**Addendum No. 2  
January 19, 2024**

Project: **Lennox High School Addition**  
Lennox, South Dakota  
Architecture Incorporated Project No.: 2982

Architect: Architecture Incorporated

## 6.10-D

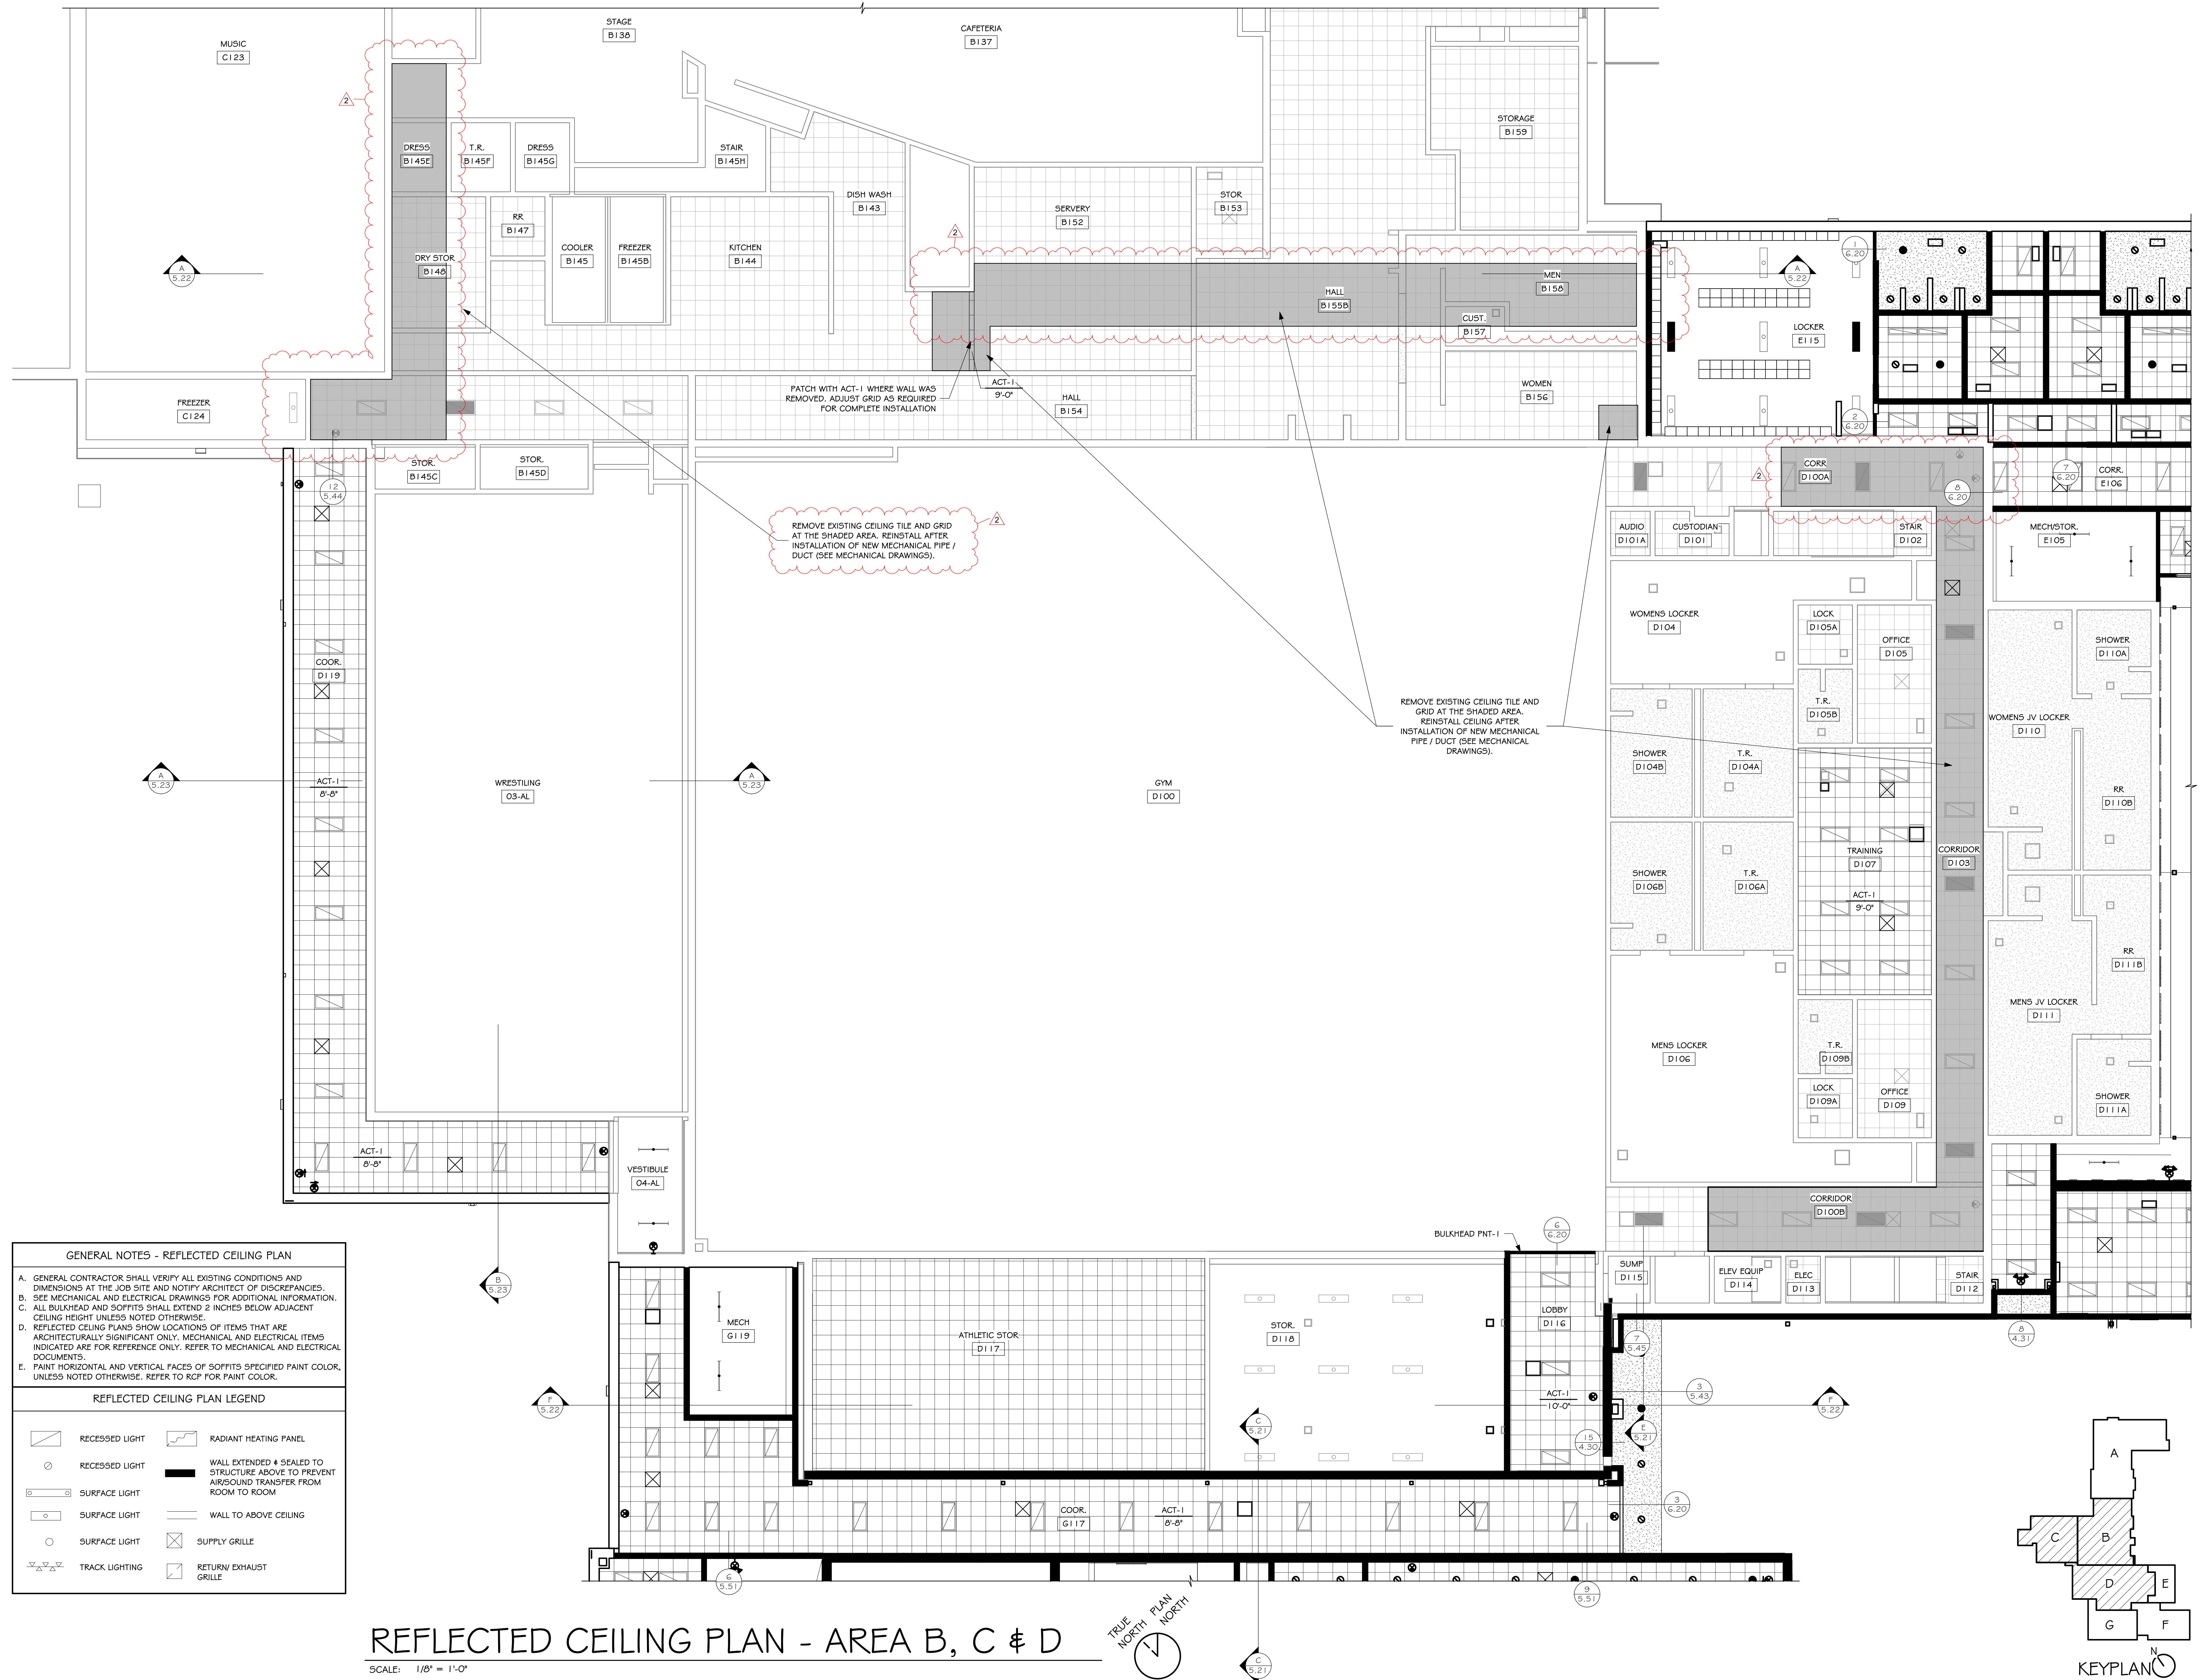
38) SHEET 6.10-D – REFLECTED CEILING PLAN - AREA B, C & D

- a) Reference *revised* drawing Sheet 6.10-D, dated 1-18-24, attached to the end of this addendum for the location of existing acoustical ceilings that must be removed and reinstalled to allow for the installation of new mechanical piping, fire sprinkler piping & electrical work.
- b) Per the Base Bid the Contractor shall include removing and reinstalling existing acoustical ceiling tiles and ceiling grid at select locations located north of the existing CAFETERIA to allow for the installation of new mechanical piping, fire sprinkler piping & electrical work. **NOTE:** These areas do not show up on Sheet 6.10-D.
  - i. Reference the areas shaded in gray on supplemental architectural drawing SD-2, dated 1-18-24, attached to the end of this addendum.

UNDERFLOOR PLAN - AREA E - PLUMBING

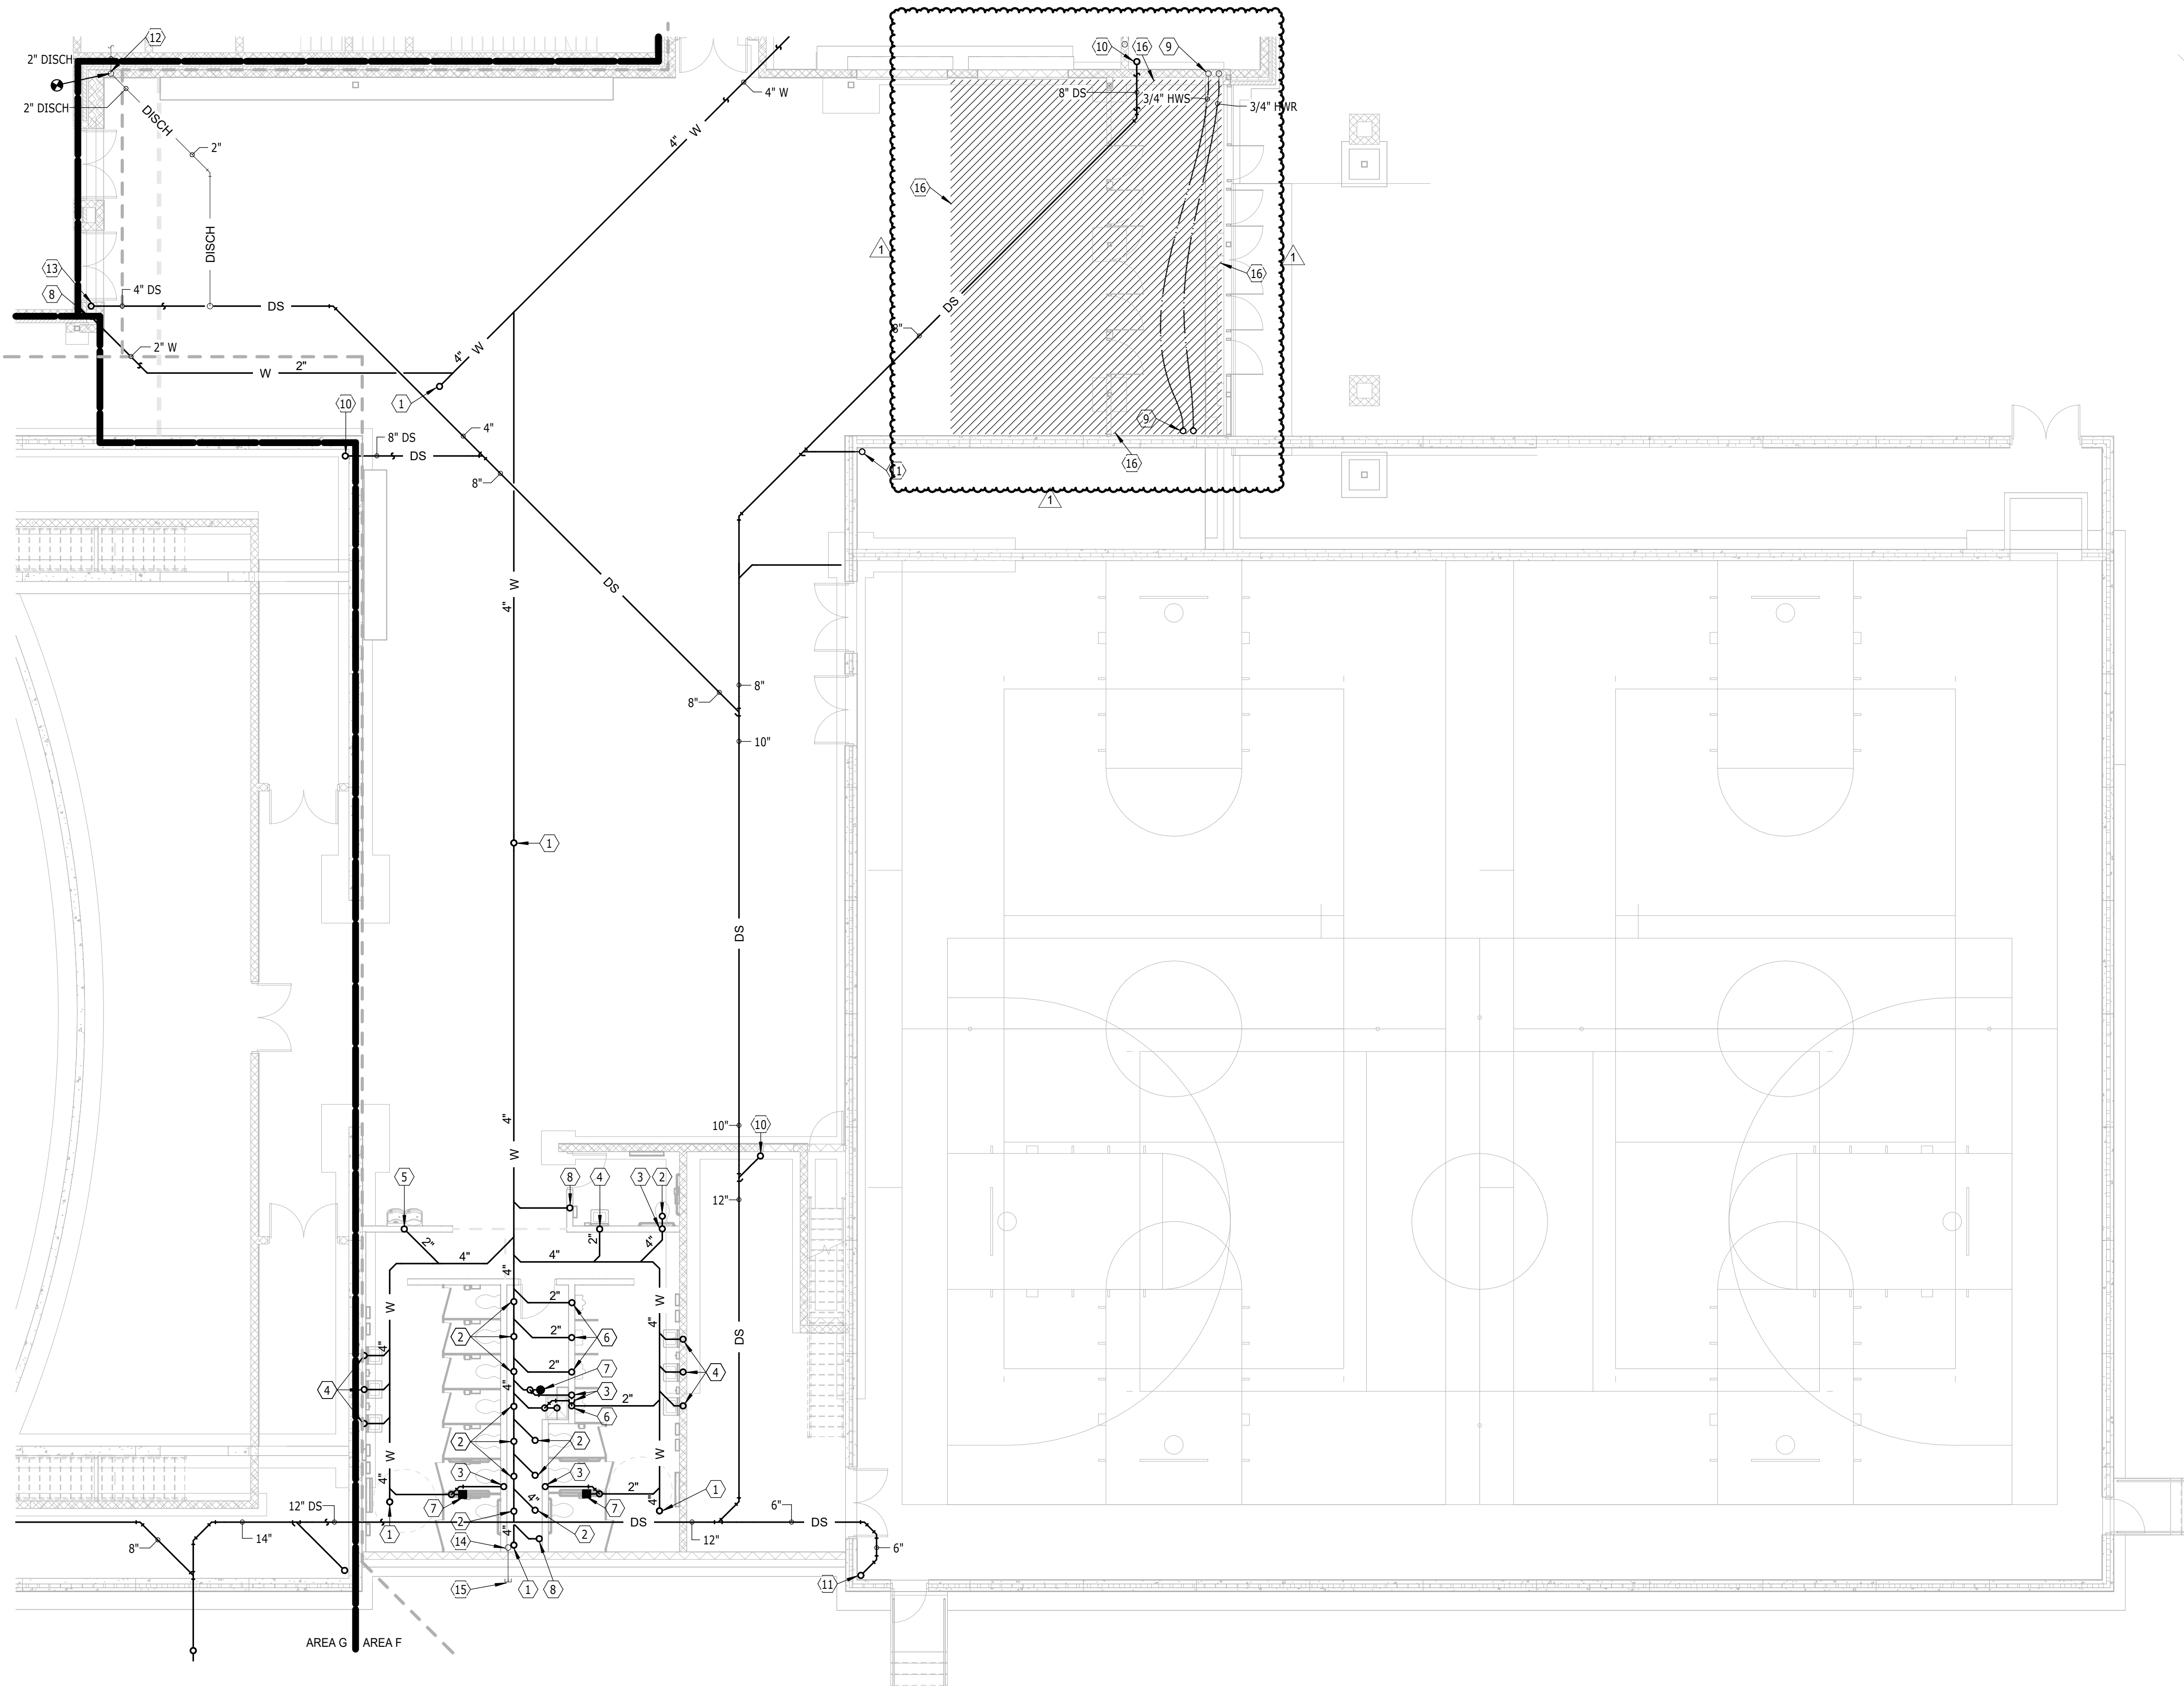
2) SHEET 8.30-E – UNDERFLOOR PLAN – AREA E – PLUMBING

- a) Add infloor heat zone & accessories as indicated per *revised* mechanical drawing Sheet 8.30-E, dated 1-18-24, attached to the end of this addendum.

8.30-F

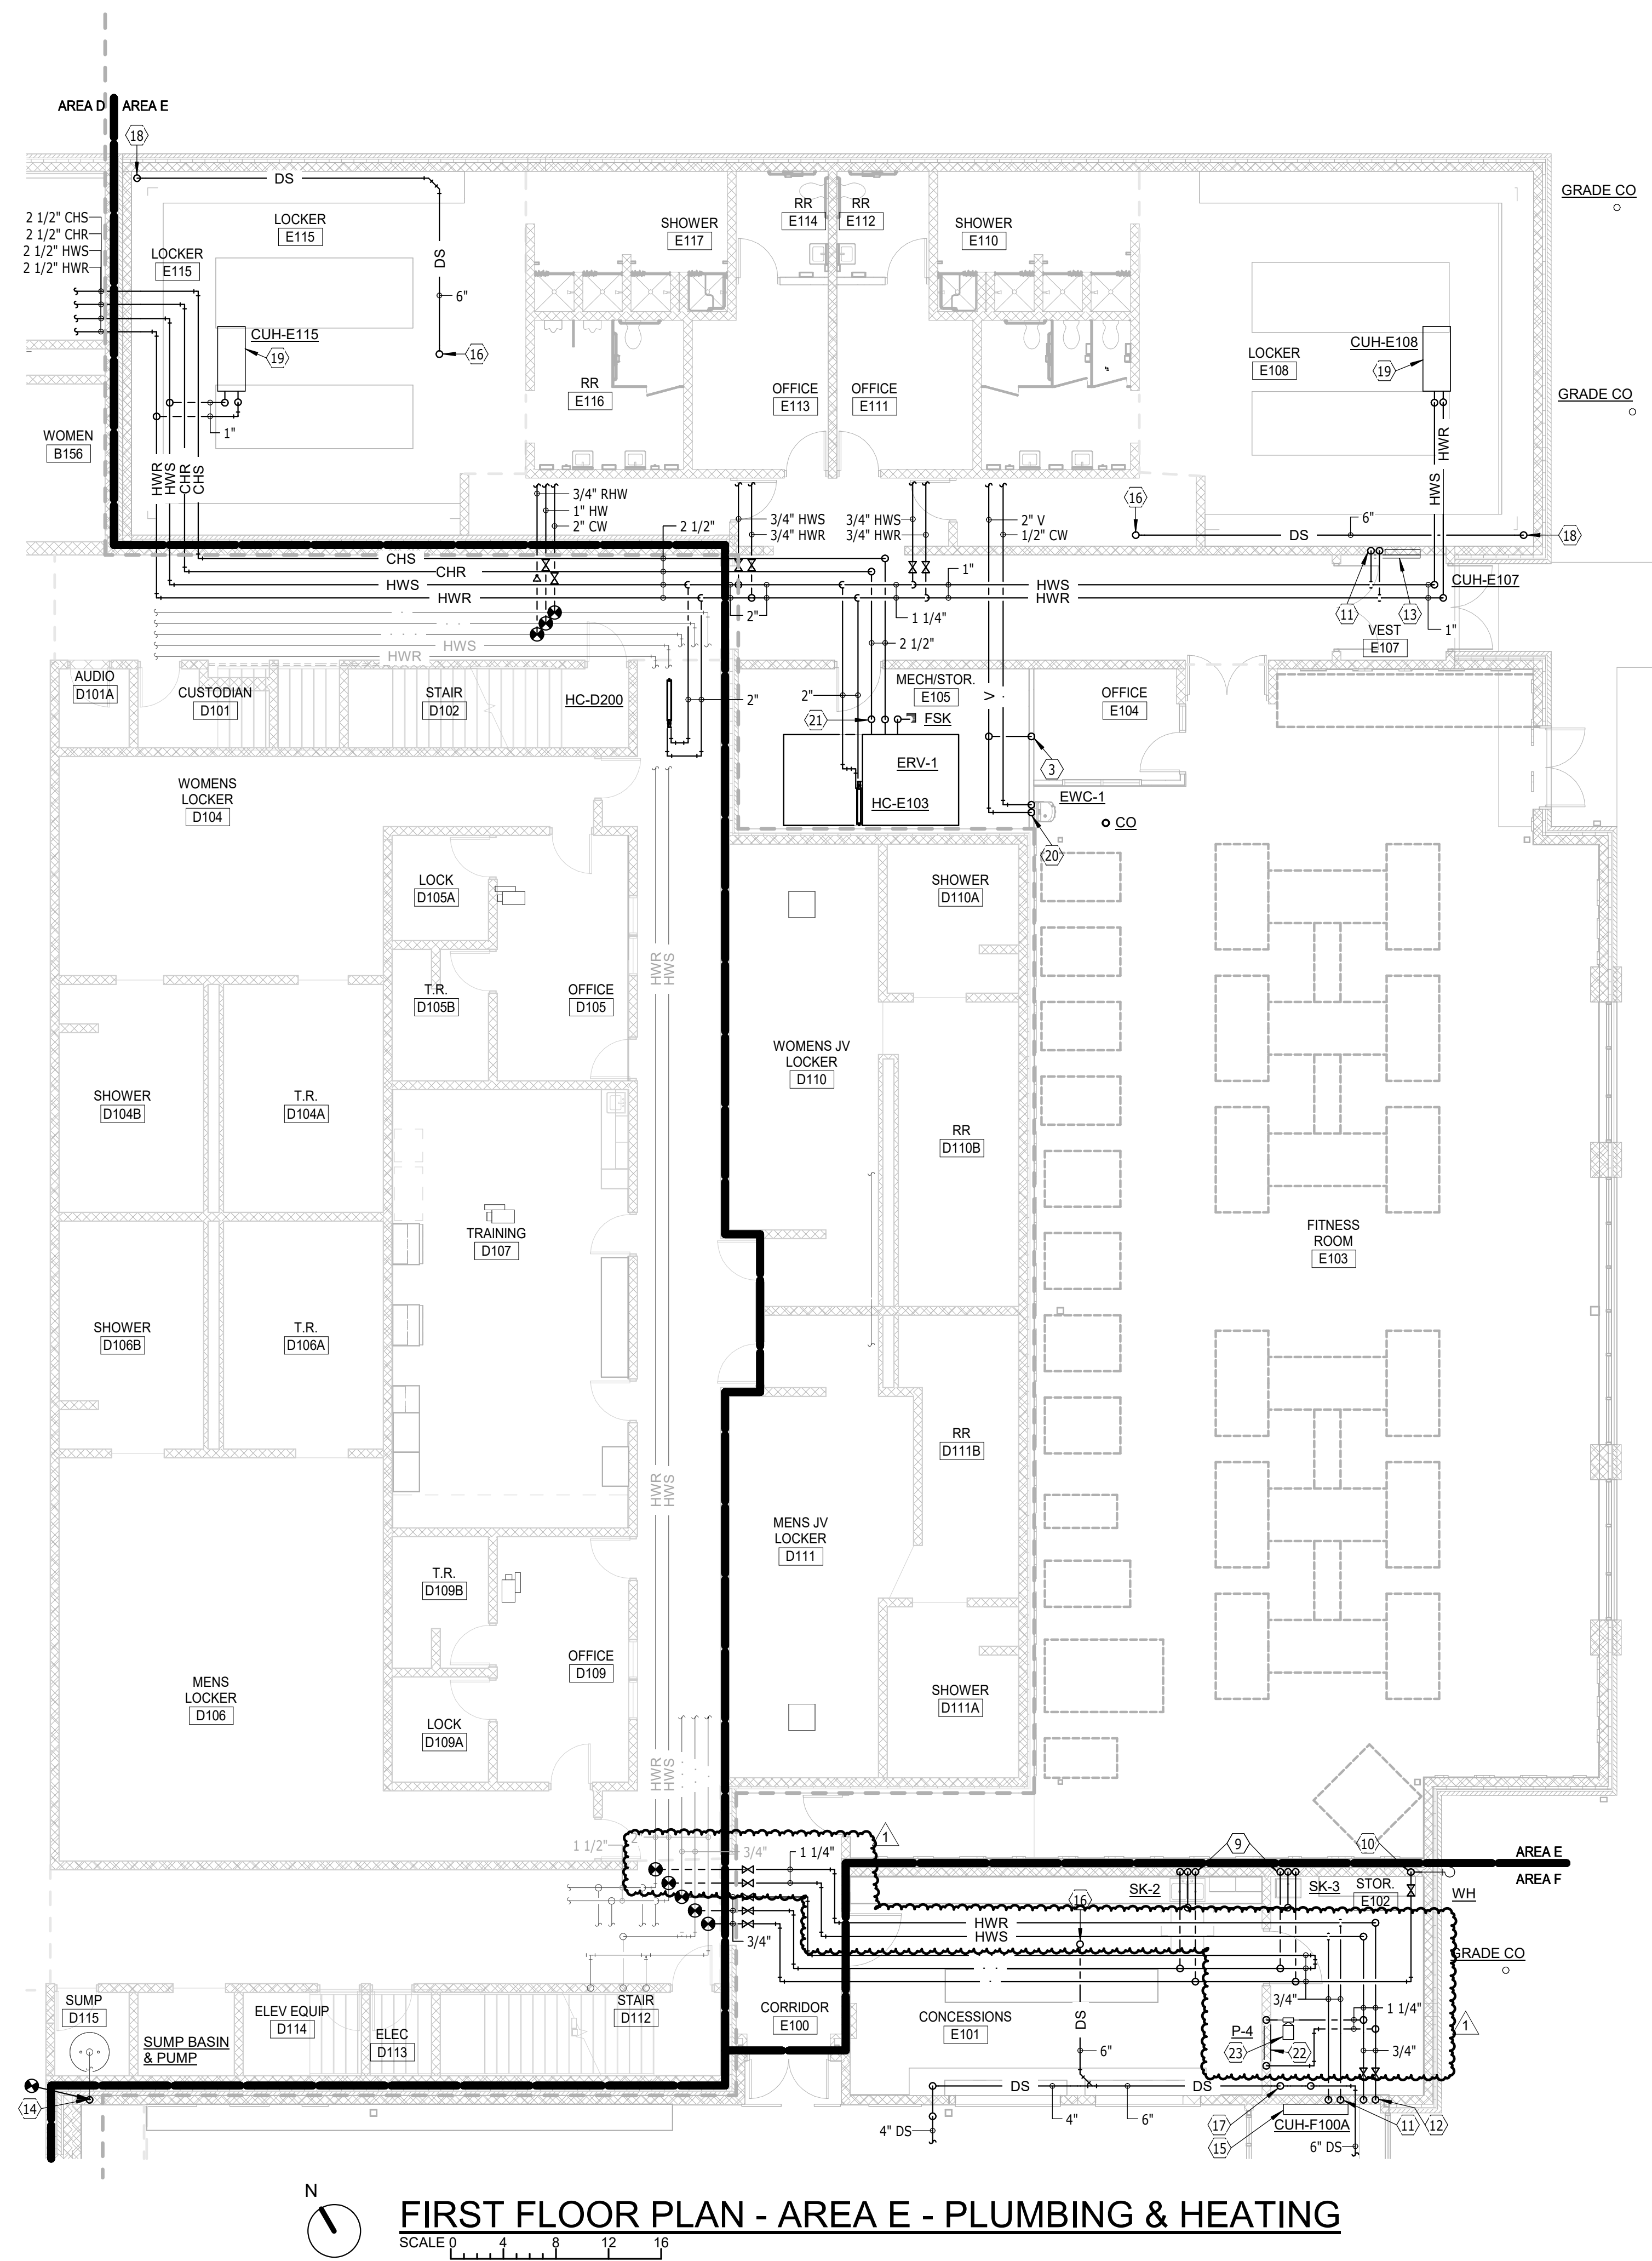
3) SHEET 8.30-F – UNDERFLOOR PLAN – AREA F – PLUMBING

- a) Add infloor heat zone & accessories as indicated per *revised* mechanical drawing Sheet 8.30-F, dated 1-18-24, attached to the end of this addendum.
